Addendum No.: 2

York Correctional Institution Central Plant and Piping Distribution

BI – JA – 465

The following clarifications are applicable to drawings and specifications for the project referenced above.

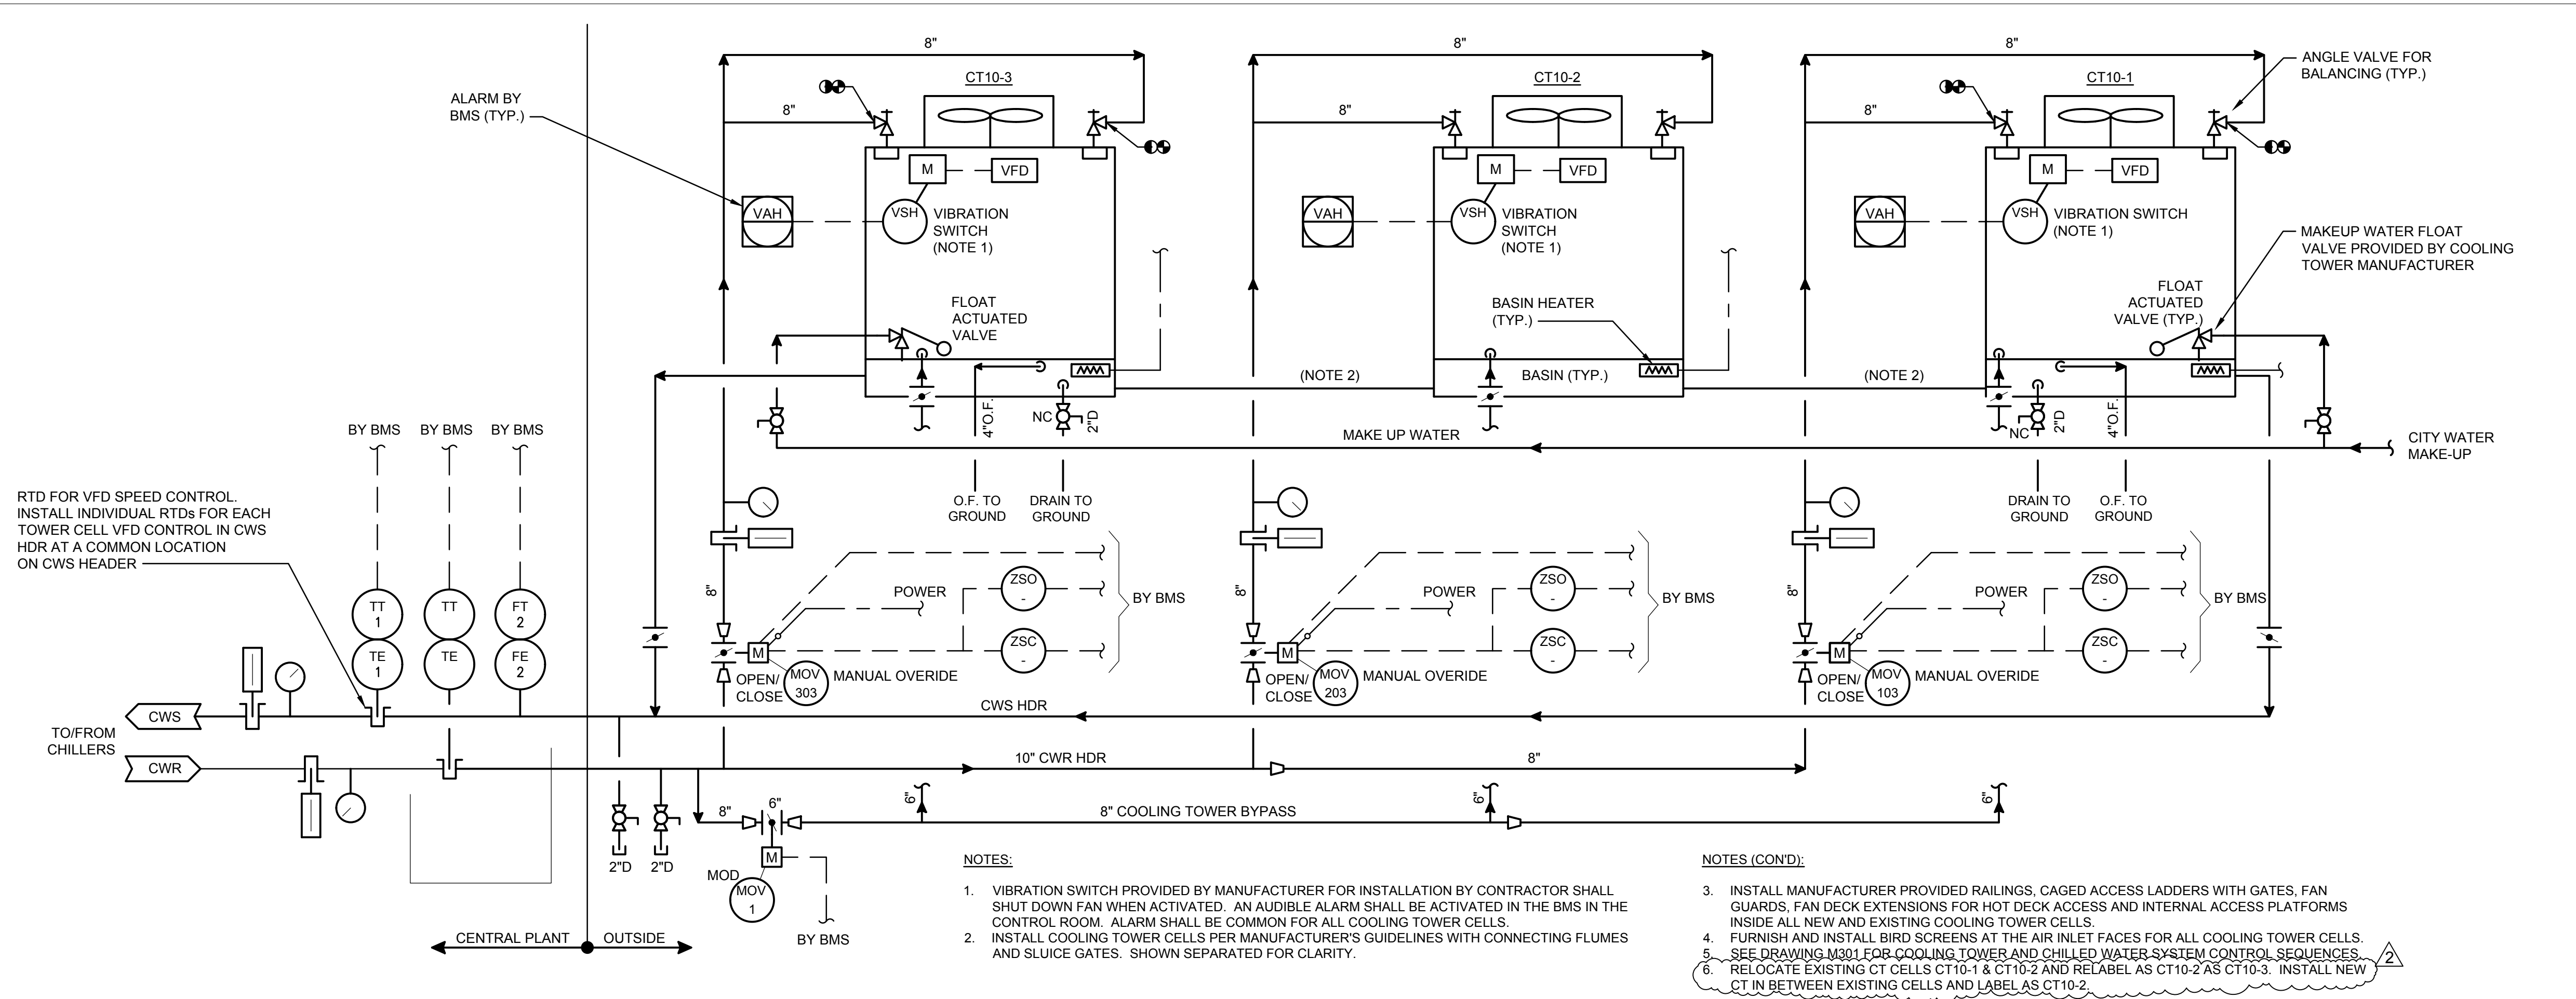
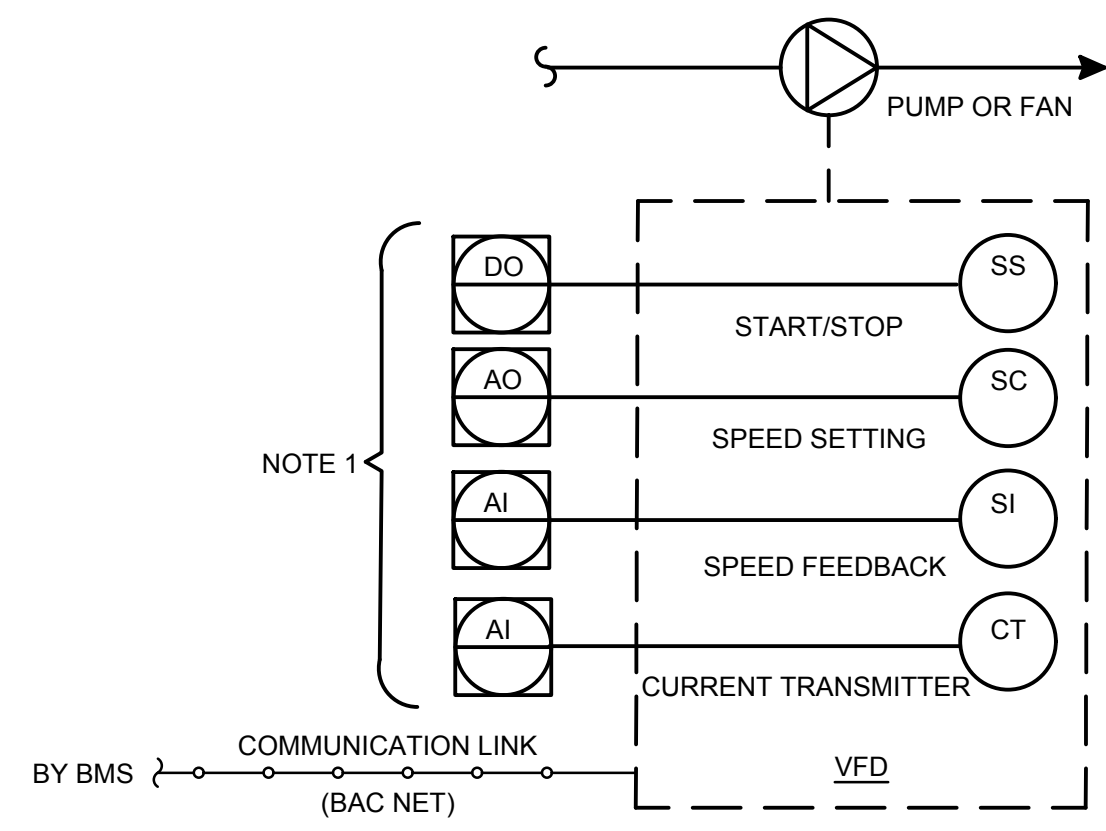
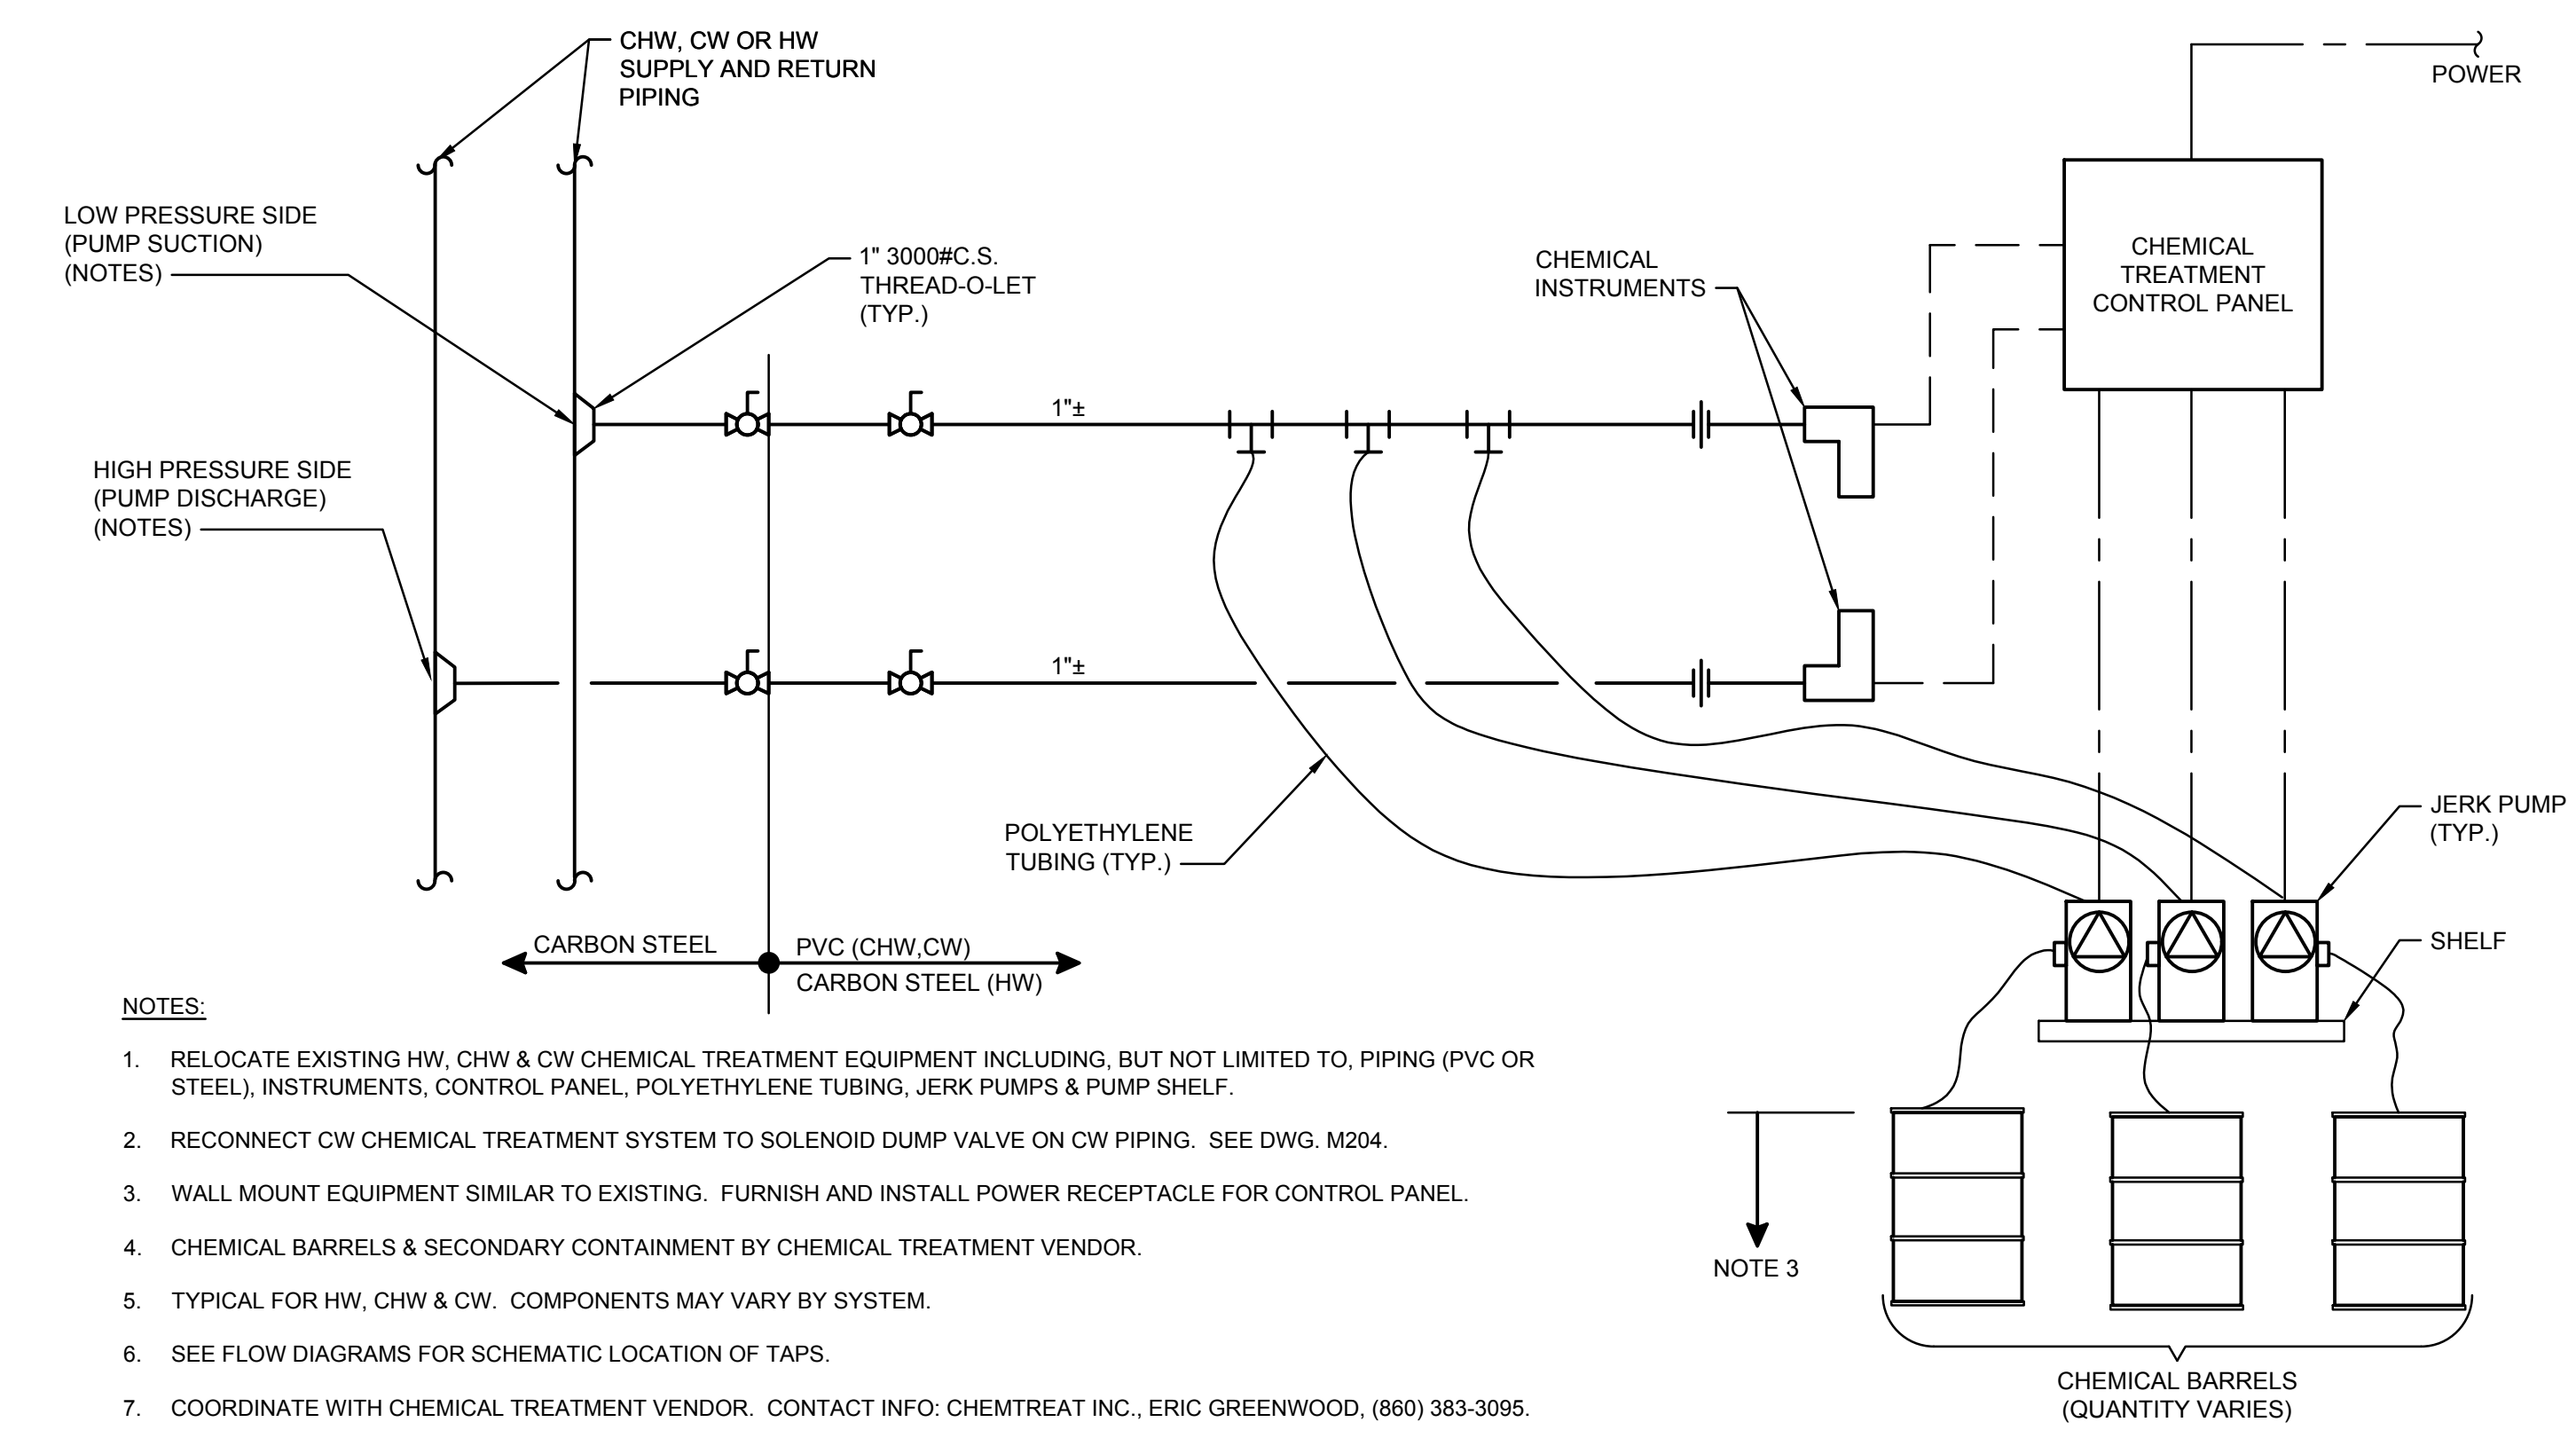
Drawing M907 Details - 8

**REPLACE** the entire drawing with the attached.
